Unicorn Board Enclosure2

Unicorn Tower printed circuit board (PCB) shorting out due to splashing.

Splash Proof Enclosure

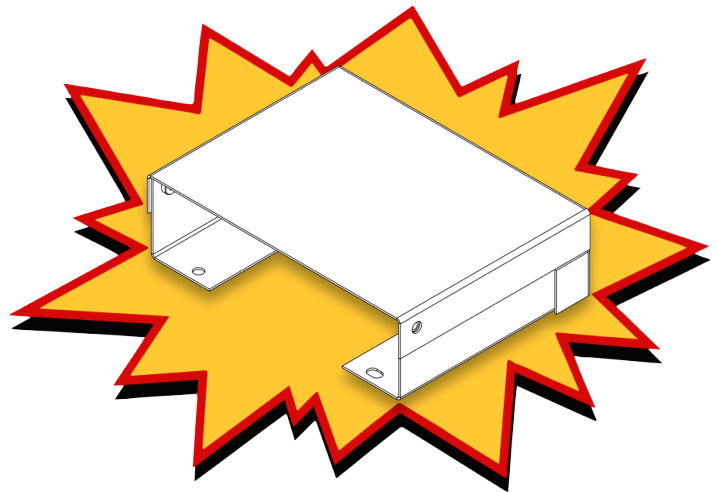
Splashing is often seen in these applications for various reasons like mishandled drinks, loose connections, etc.

Concerned with the potential of splashing, Lancer has taken this feedback as an opportunity to enhance the design.

While not intended to be a watertight seal, the redesigned enclosure provides an effective method to deflect splashed liquid, thereby protecting the components and performance of the PCB.

Order kit PN: 82-7107 to upgrade your tower.
